Supporting Material for Comment #21

Comment #21

Table 80–2—Nomenclature and clause correlation (40GBASE)

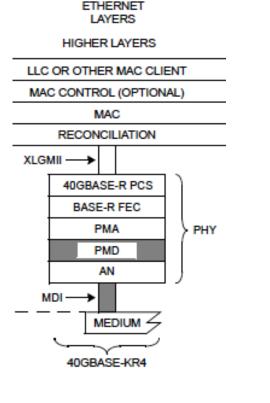
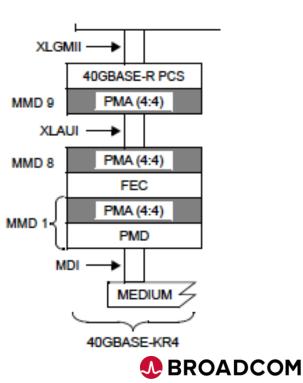
• FEC is optional to exist, so you can end up with two different stack ups.
